AMENDMENTS TO THE DRAWINGS:

CISCO-3024

FIG. 3

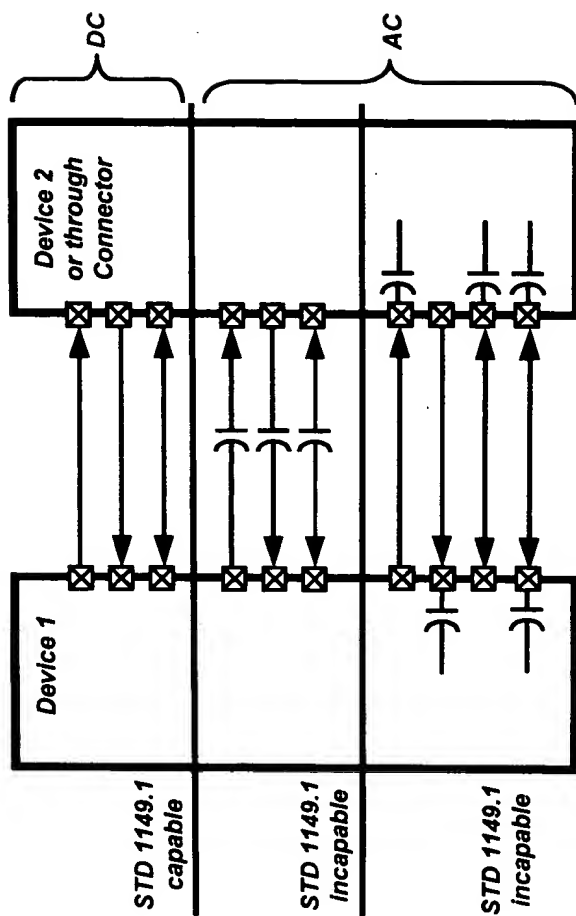
The attached sheets of drawings includes changes to FIGS. 1-3 and 5. These sheets replace the original sheets including FIGS. 1-3 and 5. In FIGS. 1-3, the legend Prior Art has been added. In FIG. 5, the designations of X1 and X2 have been clarified with respect to specification page 16, lines 9-14.

PRIOR ART
